Access Compliance Report

Public Rights-of-Way

(Curb Ramps)

Intersection ID: 16545	Main Street: N_SHARON_AMITY_RD	Cross Street: MONROE_RD	Location: NW
ADA ID: 2CE0E16DE59A	Ramp Type: Perp	Initial Pass/Fail: Fail	Overall Compliance: No
Severity Score: 8.75			
Codes/Mitigation Info/Possible Solution		Field Measurements/Component Compliance

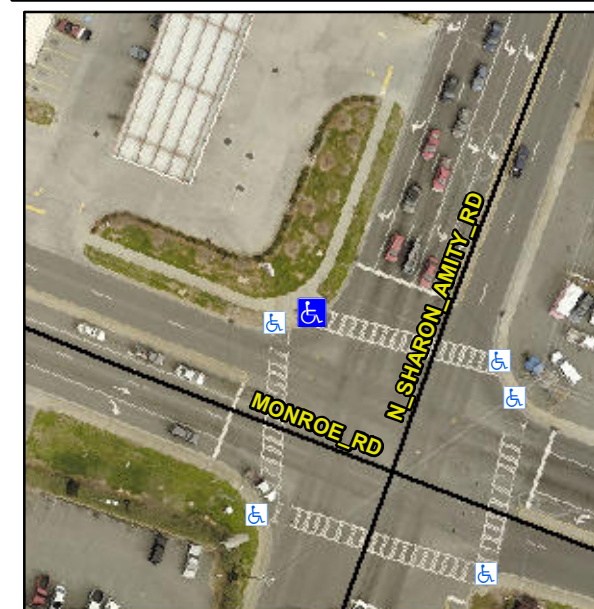
Not Found, R304.5.1

Compliance	Description	Data	Compliance	Description	Data
N/A	Ramp Length (in)	60.0	Yes	Ramp Slope (%)	5.2
No	Ramp Width (in)	37.0	Yes	Ramp XSlope (%)	1.3
N/A	Flare Type LT	N/A	N/A	Flare Type RT	N/A
N/A	Flare Slope LT (%)	N/A	N/A	Flare Slope RT (%)	N/A
N/A	Flare Traversable LT?	N/A	N/A	Flare Traversable RT?	N/A
N/A	Landing Length (in)	N/A	N/A	DWS Provided?	N/A
N/A	Landing Width (in)	N/A	N/A	DWS Contrast?	N/A
N/A	Landing Slope (%)	N/A	N/A	DWS Length (in)	N/A
N/A	Landing X Slope (%)	N/A	N/A	DWS Full Width?	N/A
N/A	Landing Curb? (Y/N)	N/A	N/A	DWS Offset (in)	N/A
N/A	Shared Landing?	N/A			
N/A	Gutter Ponding?	N/A	N/A	Gutter Slope (%)	N/A
N/A	Gutter Lip Ht (in)	N/A	N/A	Gutter X Slope (%)	N/A
N/A	Painted X Walk1?	Yes	N/A	Painted X Walk2?	N/A
	X Walk 1 Direction	To SE		X Walk 2 Direction	N/A
N/A	X Walk 1 Width (in)	107.0	N/A	X Walk 2 Width (in)	N/A
	X Walk 1 Slope (%)	1.2		X Walk 2 Slope (%)	N/A
	X Walk 1 X Slope (%)	0.8		X Walk 2 X Slope (%)	N/A

Remove & Replace Entire Ramp.
